Proposed Large Scale Residential Development,
Ross Rd., Killarney, Kerry.

Quality Audit Report

July 2025

Client	Homeland Group
Project Title	Proposed Large-Scale Residential Development
Project Location	Ross Rd., Killarney, Kerry
Document Title	Quality Audit Report
Document No.	25012TT-MHL-Ross Rd.Killarney LRD-Doc02-QAR
Job No.	25012TT

Figure 6.1 Photo Direction A

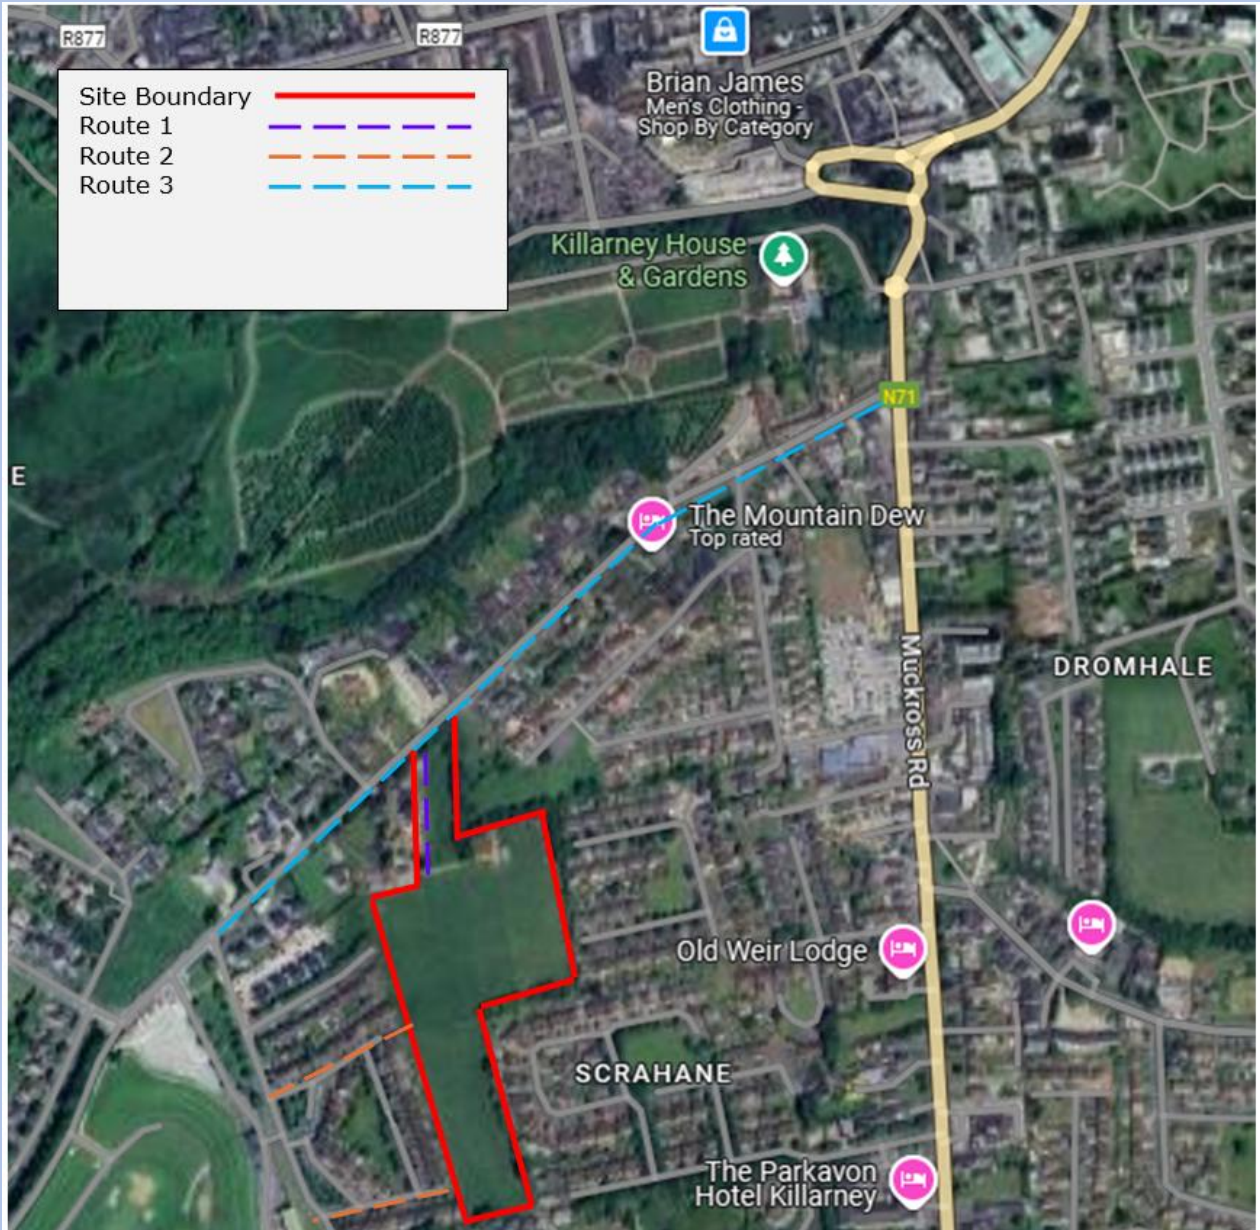
Issue: there is no footpath along the entrance of the site. Pedestrians will be unable to walk along Ross Road unless they cross the road where there is oncoming traffic. The nearest pedestrian crossing is at the Killarney Racecourse. This would involve pedestrian walking along the public road and could result in pedestrians being involved in a collision with a vehicle.

Recommendation: Provide a crossing and continuous footpath along the southern side of Ross road as proposed as part of this development. Ensure that all crossings incorporate either dropped kerbs or raised crossing tables to ensure that vulnerable road users are accommodated.

Figure 7.1 Photo Direction B

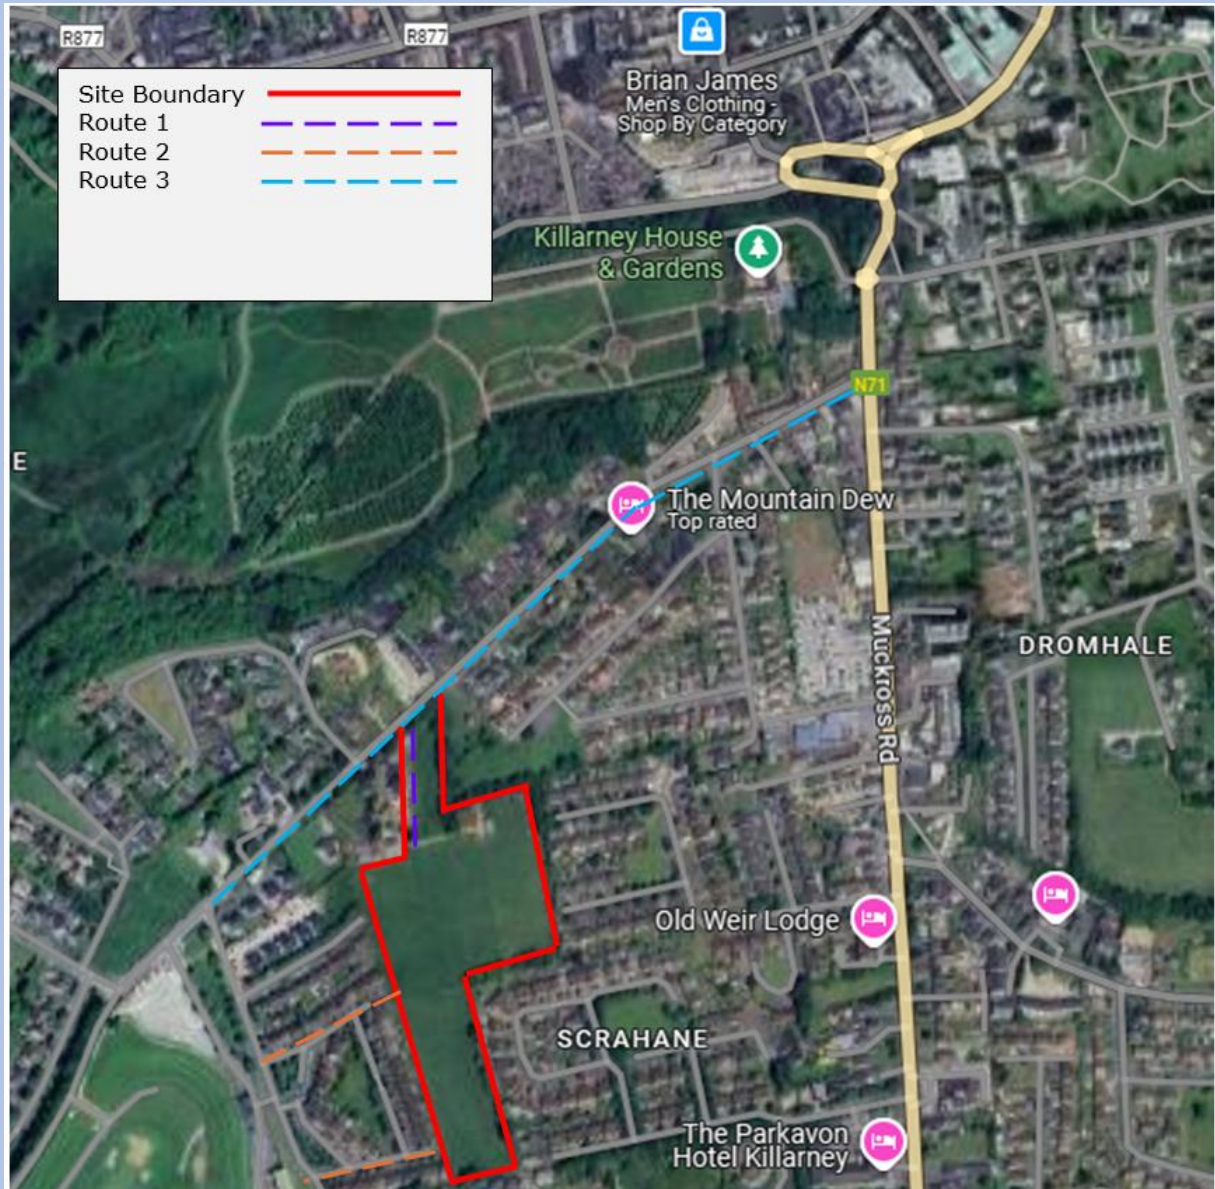
Issue: Pedestrian connectivity restricted due to no crossing, drop kerbs or tactile paving provided. Unregulated pedestrian crossings could lead to collision, injury with passing traffic.

Recommendation: Appropriate uncontrolled pedestrian crossing facilities to be provided at links between Castle falls & the Flesk Cycle & Walking Facility

Figure 8.1 Photo Direction C

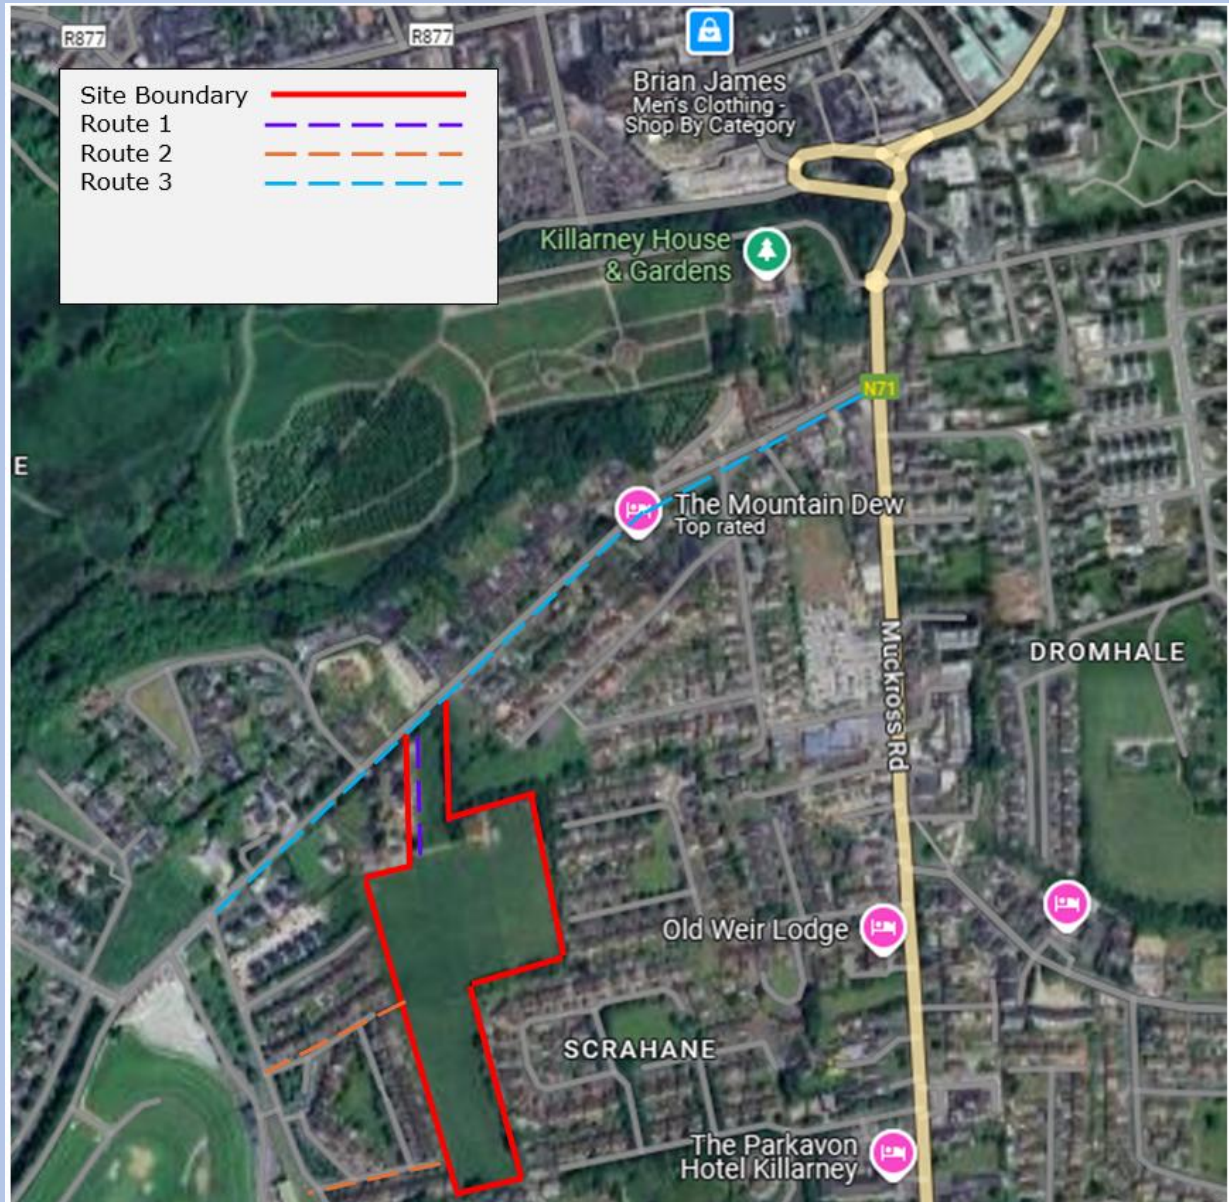
Issue: The southbound cycle lane is not provided with safety measure for any potential cyclists. No Northbound Cycle lane is provided along the route. This can cause collisions between cyclists and vehicles.

Issue: The current footpath that is on the northbound on Ross Road is uneven which may be a tripping hazard for wheelchair users and pedestrians.

Recommendation: Provide a raised cycle Track through the new junction with the development.

Recommendation: Resurface the footpath to ensure that the footpath is even and safe for it to be used.
